# UNITED STATES PATENT AND TRADEMARK OFFICE

APPLICATION NO.	FILING DATE	FIRST NAMED INVENTOR	ATTORNEY DOCKET NO.	CONFIRMATION NO.
10/815,922	04/02/2004	Hideki Tominaga	D-1587	9419

# Office Action Summary

### **DETAILED ACTION**

attachment # 1  
(office action 03/07/06)

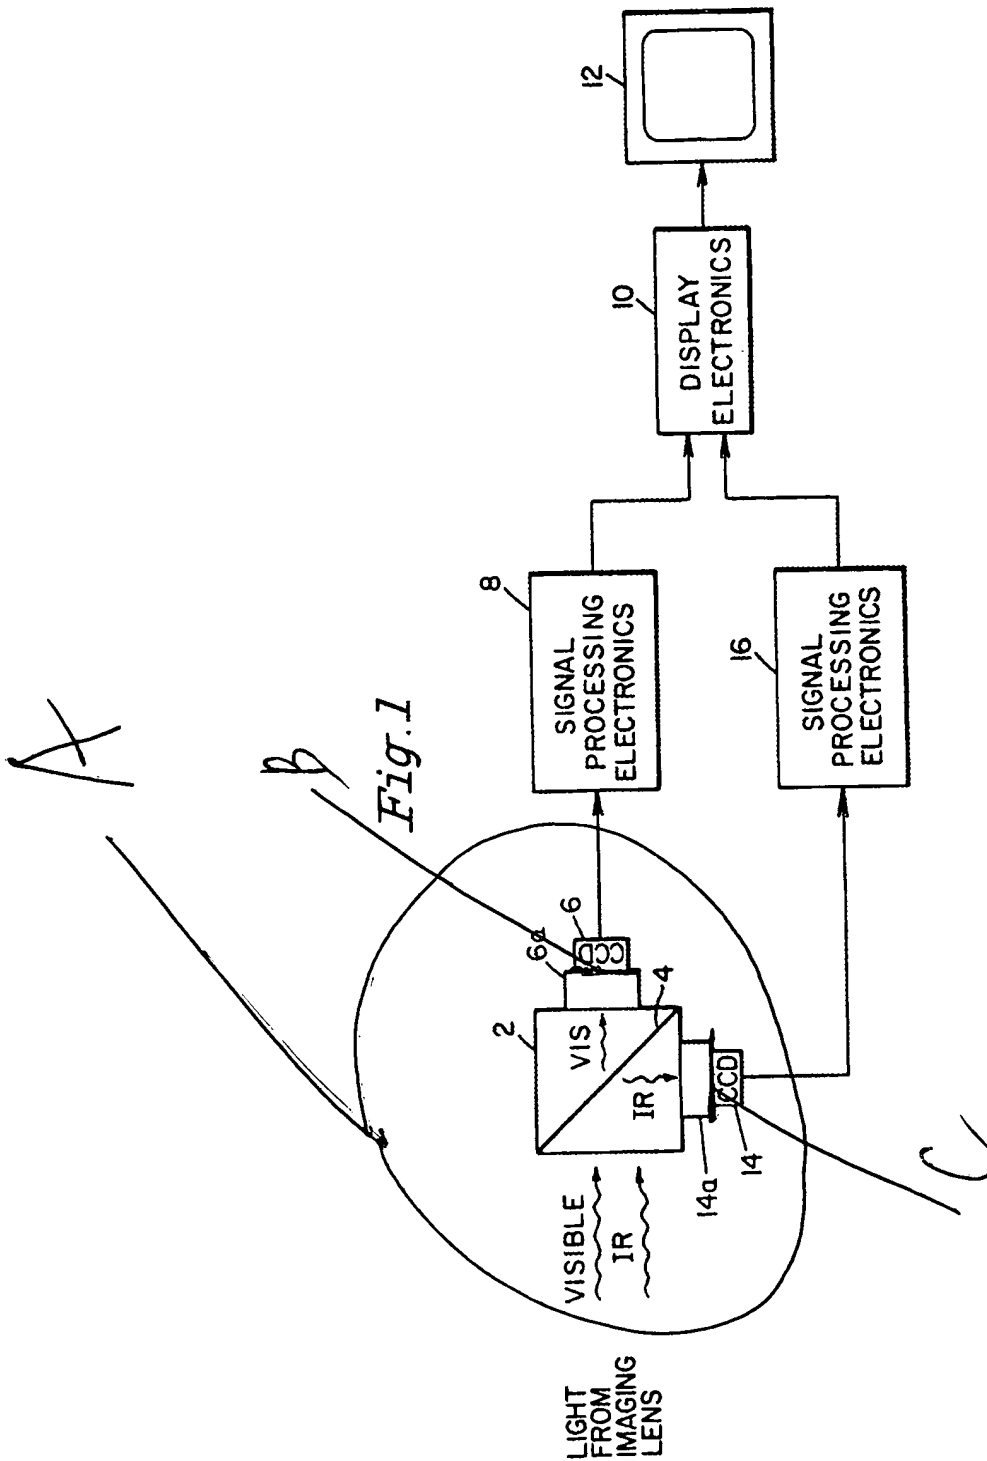
Fontenot discloses in Figs. 1, 7 a device/ assembly/ one image pickup device A for directing a visible (first wavelengths) and IR (second wavelengths) rays from a light diverging/ separating means 4 (or 84) and having a light receiving surface having two light receiving areas B and C at 90 degree to each other and comprising CCD chips 6 and 14 (plurality of two dimensionally arranged micro-photo-elements). An imaging lens directing light to said light receiving areas, wherein a first area B of the light receiving

surface is designated for first wavelengths (visible light) and a second area C is designated for second wavelengths (IR). The light diverging means comprises a prism 2 having two edges (two prism surfaces, thus, acting as two prisms), the edges (two prisms) are equipped with a (first) filter 4 to block IR and a (second) visible light blocking filter 14a, the filters 4 and 14a (or 90, 86) constituting a wavelength limitation means located in front of said areas of the image pickup device and directing said visible light and said IR to their respective first and second areas (col. 2, lines 65-67 and col. 3, lines 1-7). The device also comprises a display where the images corresponding the two wavelengths are recombined and displayed. This would imply, that the device comprising some means (processing electronics 8, 16/ temperature calculating means) for processing images and making them understandable for an operator in terms of at least IR/ thermal image, which is representative of temperature of the object of interest. (The numerals A-C have been added by the Examiner, see attachment # 1 to the Office Action).

Also, the "image pick up device" does not necessarily means a CCD camera. Thus, in the new rejection, the Examiner interprets Fontenot' s structure A as being a "one image pick up device" having two "light receiving surface areas" B and C as parts of the CCD chip 6 and the CCD chip 14 respectively. Please note, that according to Figs. 1 and 7 of Fontenot, all these elements are parts of the "one image pick up device" A.
